SEWAGE DISPOSAL SYSTEM

SUBDIVISION Allnutt Farms Estates ROAD 13425 Good Times Court LOT 29 21, Sec. 1

Pool Site Plan
 #13425 Good Times Ct.
 Highland, MD

LARGE DRAWING OF LOT

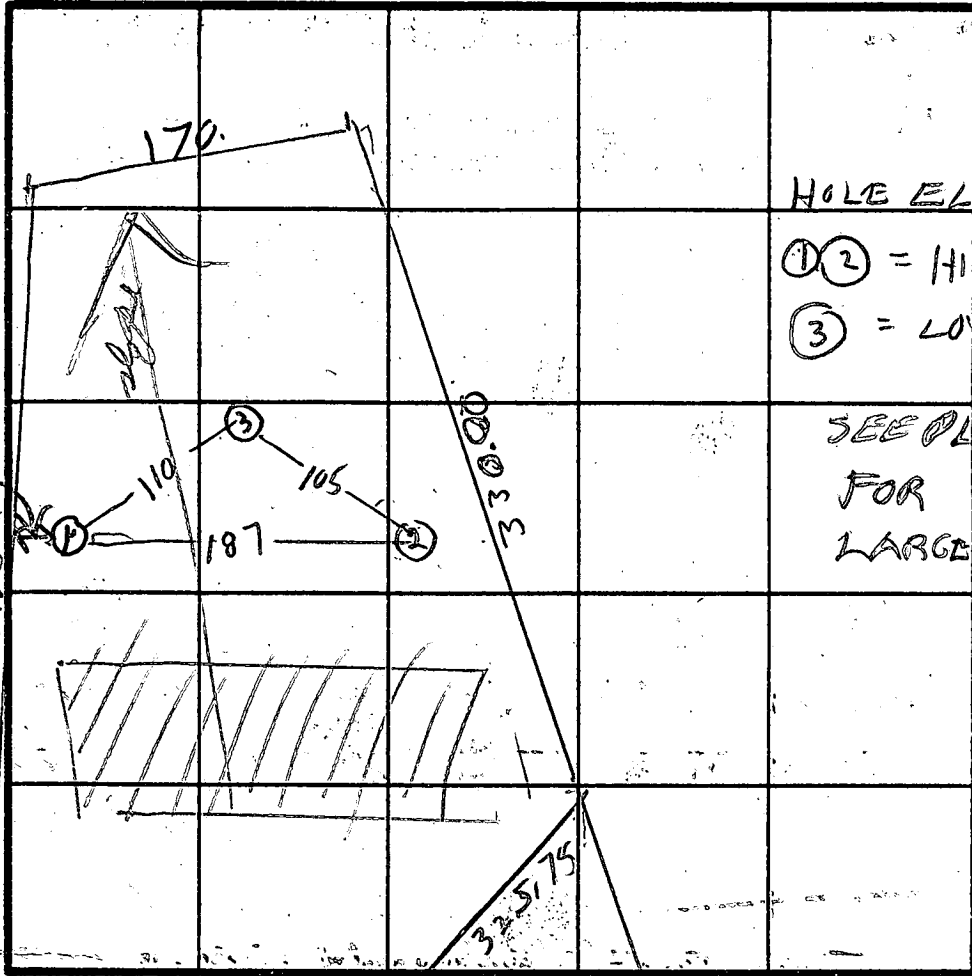
REMARKS Retest needed because proposed house site
is an existing sewage disposal area

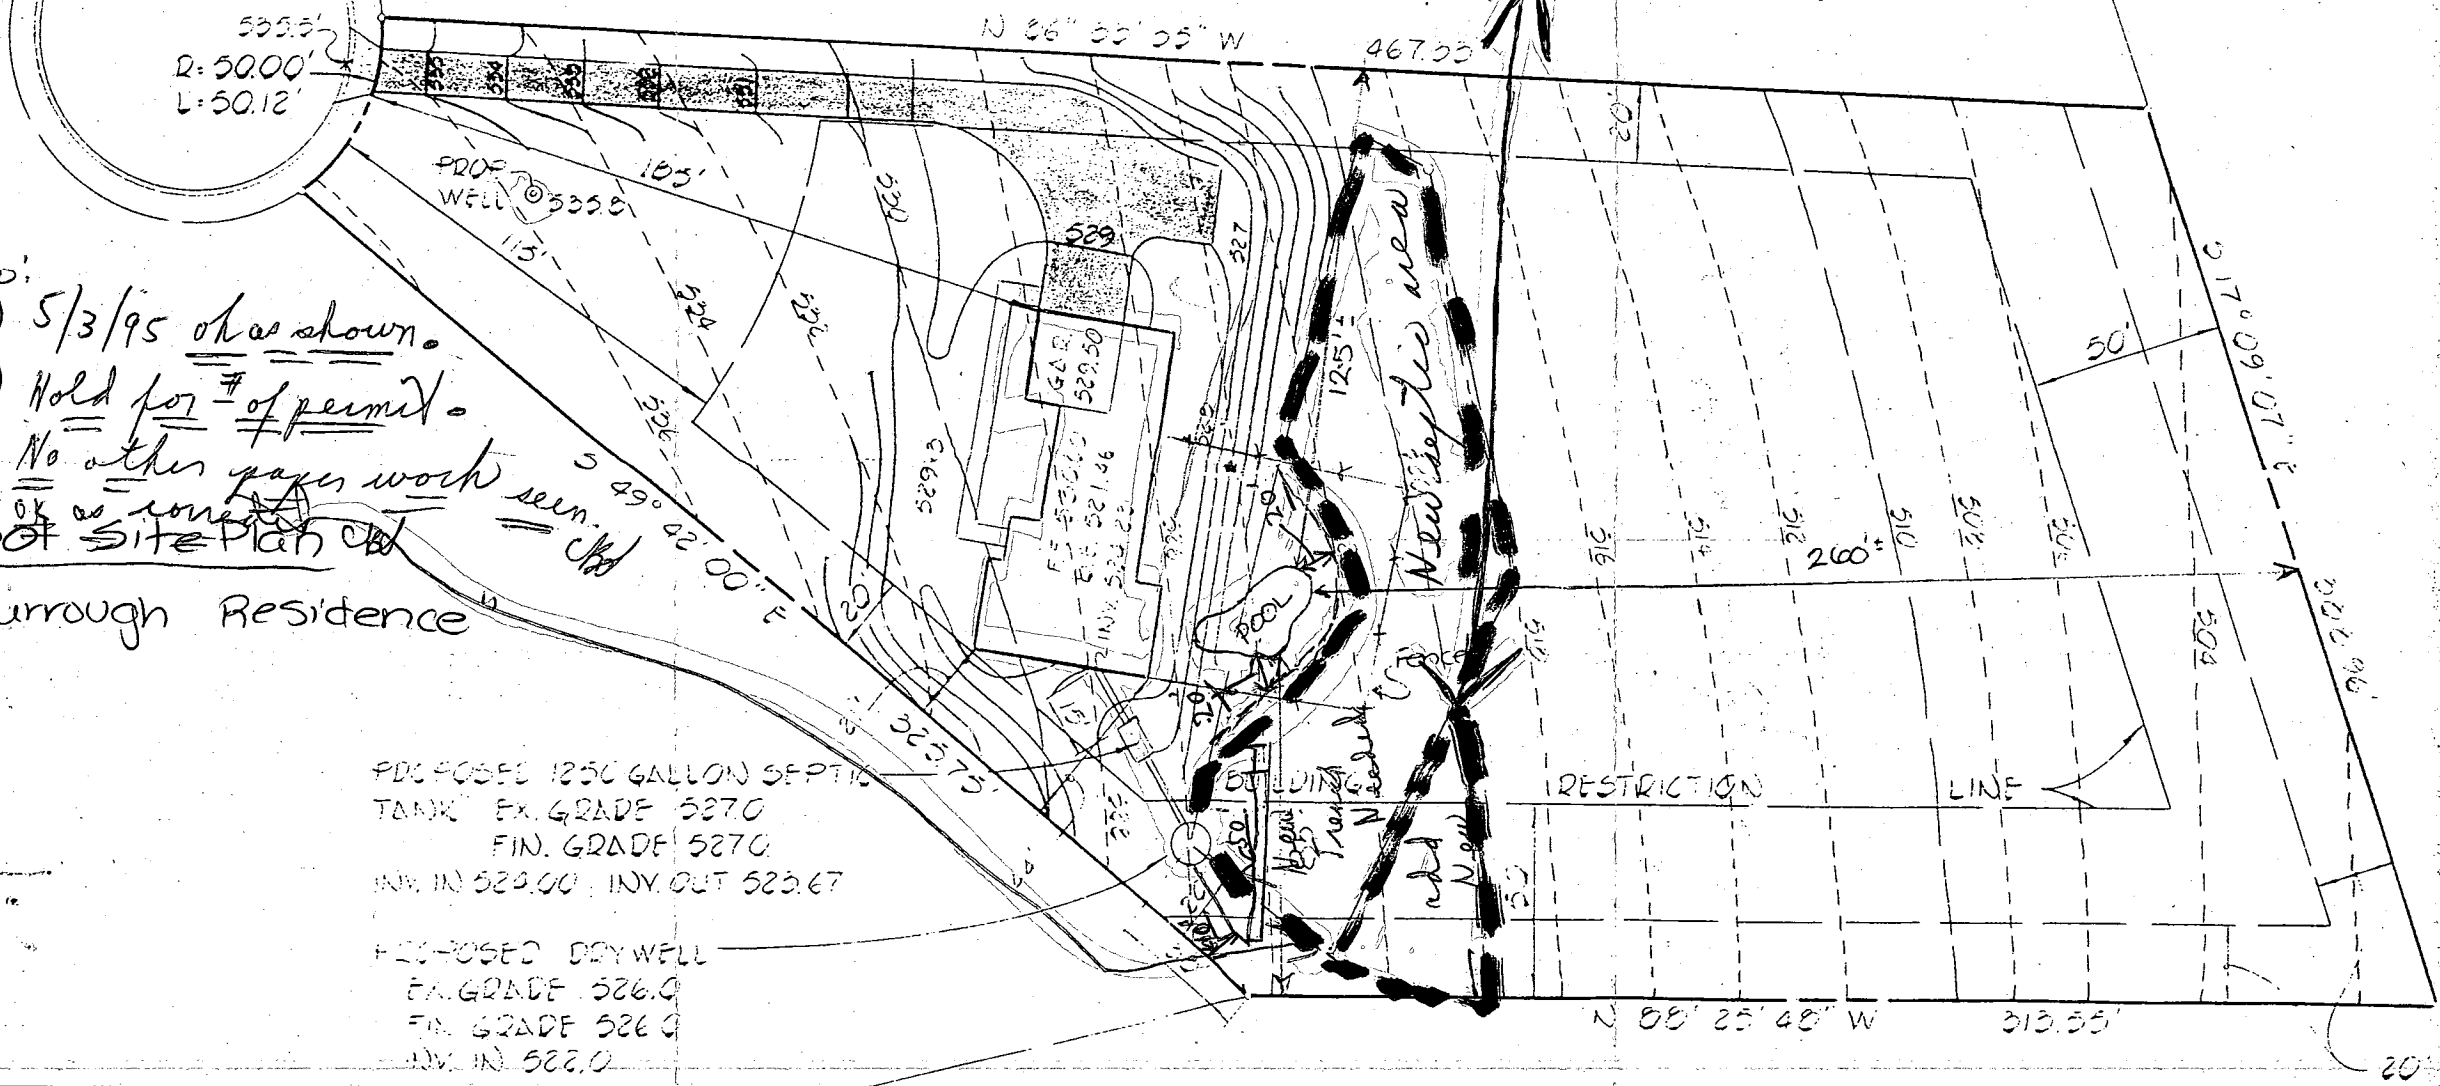
See below
 5/3/95 Needs a repair permit
 Found drain C.O. 7/5/84

5/3/95 Called owner
 Confirmed drain
 Notes ④ continued
 Recommend
 Add new septic area to make up for pool embankment existing septic casehead

New septic area
 5/3/95
 CBD

Needs to repair or move pool
 T/C
 CBD

- Notes:
- ① 5/3/95 ok as shown.
 - ② Hold for # of permit.
 - ③ No other paper work
 - ④ OK as corrected
 FOOT SITE PLAN see CBD

OK AS SUBMITTED
 MINOR IMPACT
 TO SEPTIC AREA
 5/15/95
 C. Williams
